WM-39/MFW/85/06/12

MEMORANDUM FOR: Myron H. Fliegel, WMGT  
Division of Waste Management

SUBJECT: NRC/TAC MEETING ABOUT HYDROGEOLOGIC CHARACTERIZATION  
OF THE MEXICAN HAT AND MONUMENT VALLEY UMTRAP SITES

**FIGURE 6**  
**MONUMENT VALLEY SITE MAP WITH EXISTING & PROPOSED**  
**MONITOR WELL LOCATIONS**

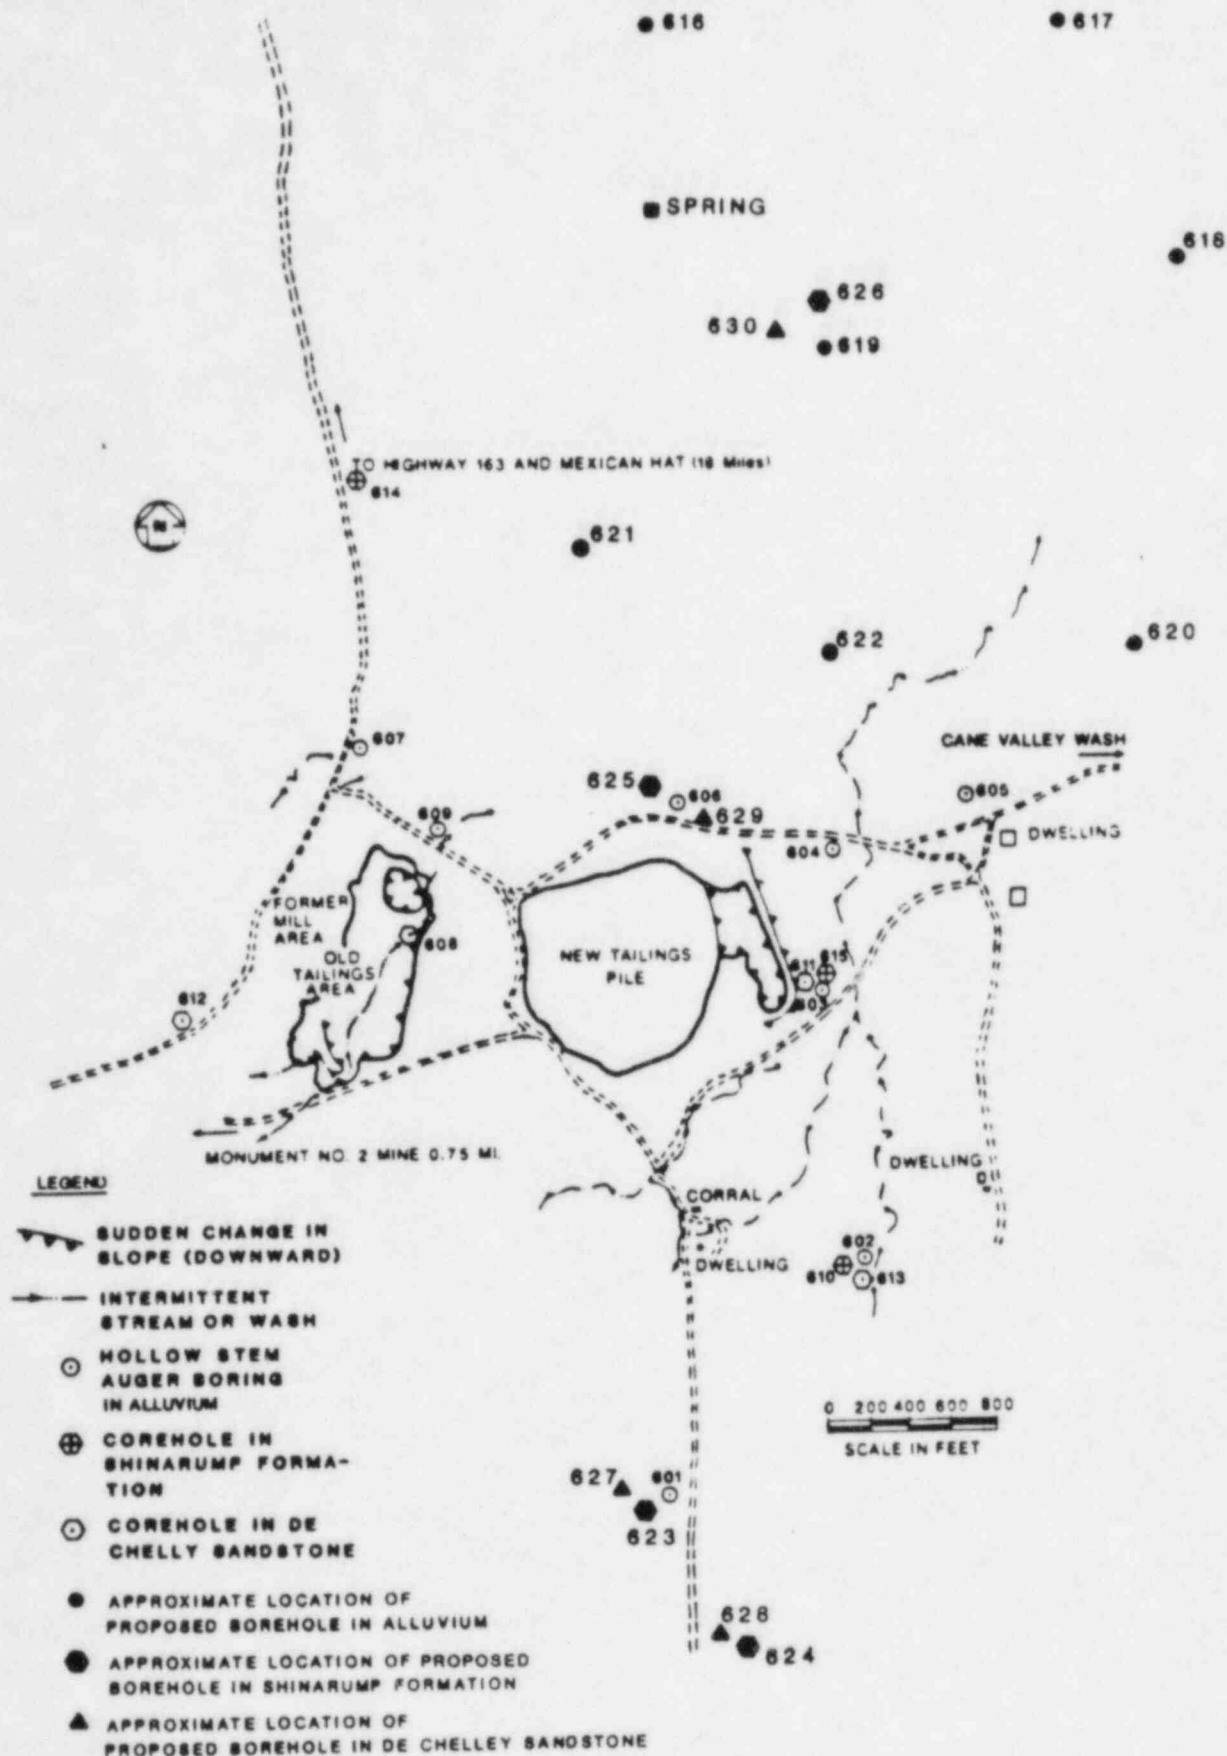
The TAC's specific purpose for the meeting was to present the proposed characterization activities and ask NRC whether these activities appeared to be reasonable based on available information. As depicted in the enclosures, the proposed activities include the installation of approximately 10 additional wells at Mexican Hat and approximately 15 additional wells at Monument Valley. Most of the meeting focused on optimal locations for these new wells. The TAC stated that well locations will be adjusted following our meeting to optimize the value of information to be collected from the wells.

At the conclusion of the meeting, we stated that the proposed characterization activities constituted a reasonable approach based on information available to us at this time, but that additional characterization may be necessary depending on analyses of results obtained from the new wells or other sources. The TAC recognized the potential need for an iterative approach for site characterization and stated that they will make their best effort to prepare a defensible evaluation for comparison against the EPA standards. The TAC also agreed to provide NRC with copies of the proposed Statements of Work (SOW's) and data files consisting of site-specific hydrogeologic information that the TAC has collected at these sites and the Tuba City UMTRAP site.
